UNITED STATES PATENT AND TRADEMARK OFFICE

APPLICATION NO.	FILING DATE	FIRST NAMED INVENTOR	ATTORNEY DOCKET NO.	CONFIRMATION NO.
10/828,716	08/30/2004	Brian C. Case	PA-5380-RFB	4764
9896	7590	11/09/2007		
COOK GROUP PATENT OFFICE			EXAMINER	
P.O. BOX 2269			STEWART, ALVIN J	
BLOOMINGTON, IN 47402				
			ART UNIT	PAPER NUMBER
			3774	
			MAIL DATE	DELIVERY MODE
			11/09/2007	PAPER

Office Action Summary	Application No. 10/828,716	Applicant(s) CASE ET AL.	
	Examiner Alvin J. Stewart	Art Unit 3738

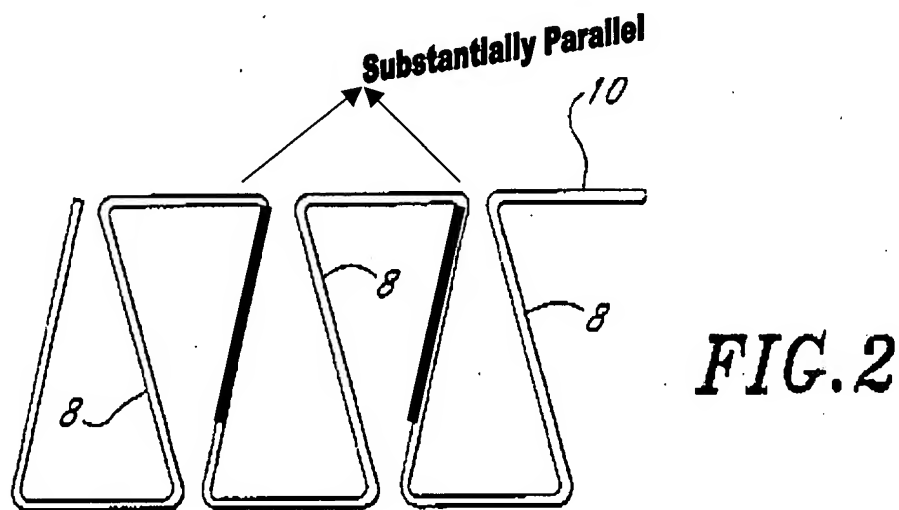
Regarding claim 13, the Applicant's representative discloses that the pockets between the leaflets and the wall of the bodily passage is not disclose in the Moll reference. The Applicant's representative discloses that the Moll reference includes pockets that are formed between sheets of the valve material (see Fig. 6 and the description of element 22 at the top of column 4).

Regarding the above applicant's remarks the Examiner agrees with the Applicant's representative arguments disclosing that the Moll device includes pockets that are formed between sheets of the valve material. However, the Applicant's representative is claiming pockets that are located between the leaflets and the walls of the bodily passage. Therefore, the Moll reference clearly disclose pockets between sheets and clearly disclose pockets between the leaflets and the walls of the bodily passage. For example, see Fig. 1 disclosing pockets (16) between the inner wall (12) of at least one leaflet and the wall of the bodily passage (20) (see Fig. 6). Figure 6 clearly disclose pockets between the leaflets and the walls of the bodily passage.

Finally, the Examiner wants to clarify the interpretation of the Moll device. The implant comprises three stoppage elements (6) around the circumference of the implant, the three elements (6) form a valve structure, each stoppage element comprises an outer wall (14) and a leaflet having an inner wall (12). The outer walls (14) are adapted to be touching the patient's walls of the bodily passage and between the two walls (14 and 12) pockets are created (as disclosed by the Applicant's representative). Therefore, the pockets created from the inner and

outer walls are also between the leaflets and the patient's vessel walls. For the above reasons the Examiner believes that the rejection is proper.
